HARDWARE UPDATE | NOVEMBER 2022

Revision 3 Hardware Update

DMP is now shipping 7800INT Series Keypads with Level 101 hardware.

Updated Proximity Reader Antenna

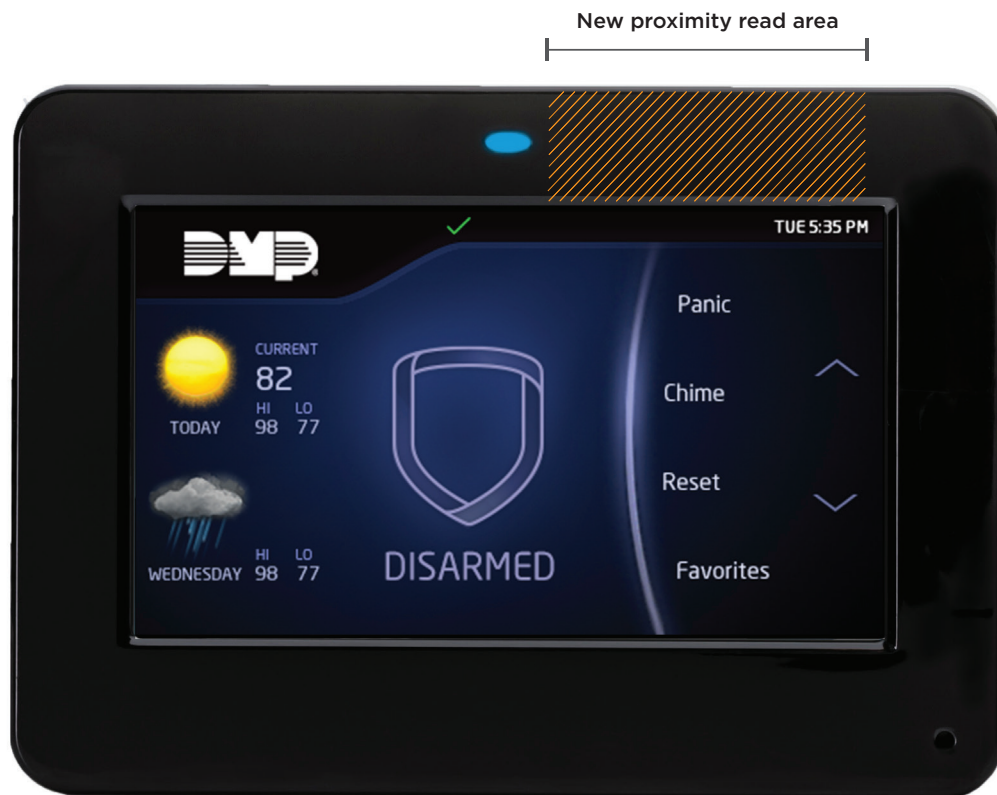
We have updated the keypad proximity reader's internal loop with a chip antenna. The placement of the new antenna on the PCB changes where users must present a credential: At the top of the housing, to the right of the keypad LED.
